# **Joint response of Suffolk Coastal District Council and Suffolk County Council to EDF Energy's Stage 3 Public Consultation**

**26 March 2019**

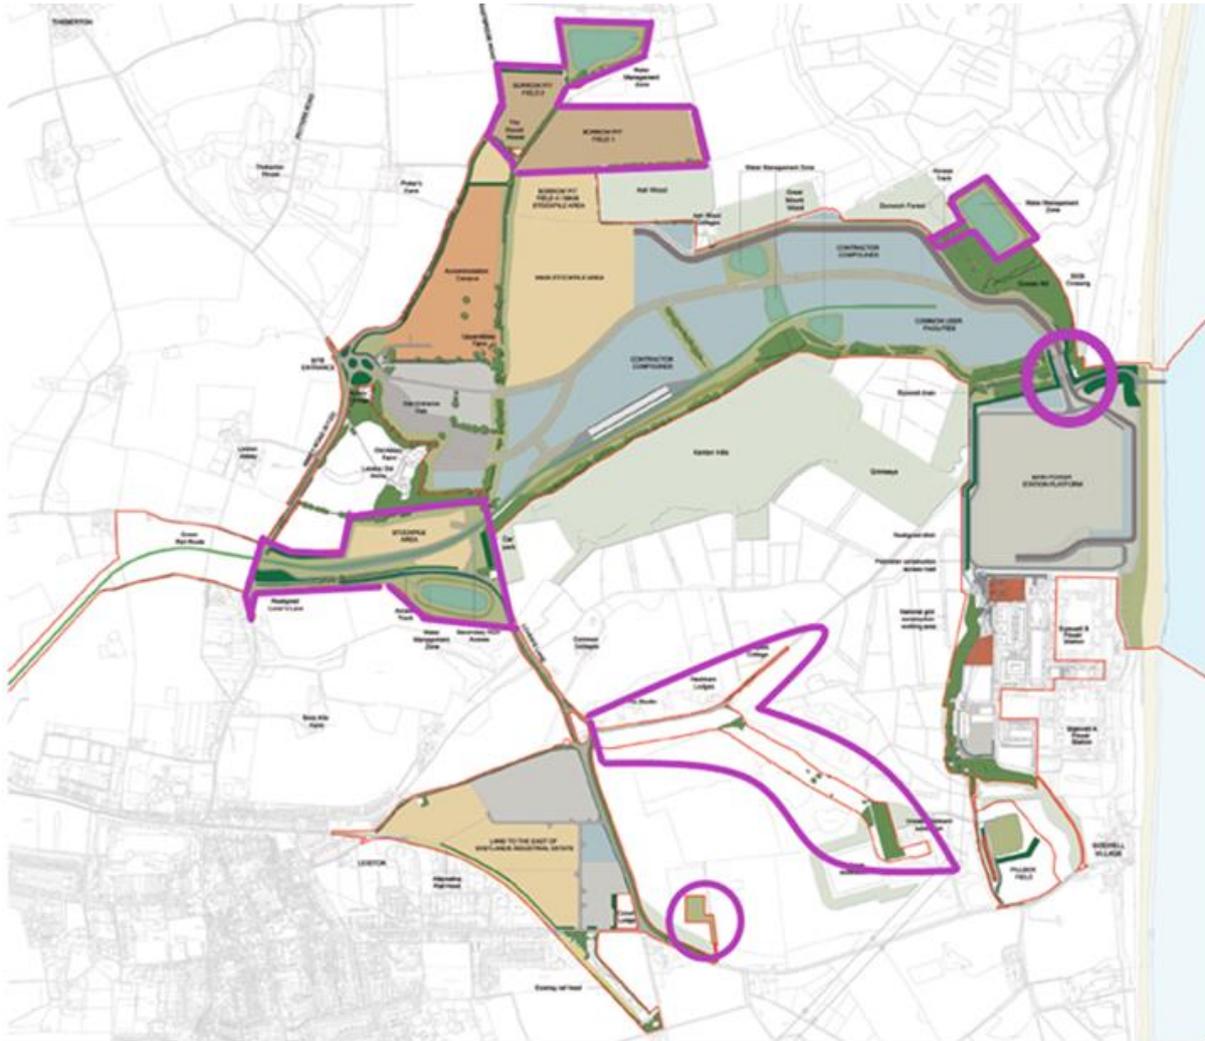
624. The Councils are concerned about the proposed height and potential impact of stockpiles on adjacent uses including potential dust transfer – particularly the impacts of the main stock piling area on the proposed accommodation campus and the stockpiling to the LEEIE on adjacent residential areas. There is no detail on how this is to be managed so we would expect an appropriate management schedule for the borrow pits and stockpiles to minimise adverse effects during the construction period.

625. The stockpiles are likely to create significant visual impacts when at their maximum height and extent during construction. It is also unclear at this stage how lighting and operation of the construction site will impact on the wider landscape and local amenity

and the degree to which these effects can be contained. Representation and assessment of effects is not fully resolved and requires further discussion and clarification. We expect that these aspects of the construction programme are fully assessed under the LVIA process, and that a fuller understanding can be given as to how the maximum impact of the stockpiles will combine with anticipated main site construction progress. The temporal phasing of operations also needs to be better understood in order to give a full and comprehensive understanding of all likely impacts.

626. The current spoil management plan remains of significant concern as is the stockpiling of other friable materials such as topsoil, sand and aggregates. Some of the areas for these activities are close to a number of residential properties (particularly the Round House, Eastbridge and Valley Road / Carr Avenue, Leiston), commercial property (particularly Eastlands Industrial Estate), as well as sensitive sites like Minsmere and Sizewell Marshes SSSI. The report states that residential and ecological receptors are not expected to be sensitive to dust deposition and mitigation measures will be introduced. These include; the formation of hard surfaced roadways, a 5 metre seeded bund on the site boundaries, water suppression sprays, dampening of work areas, together with a construction site dust management plan.
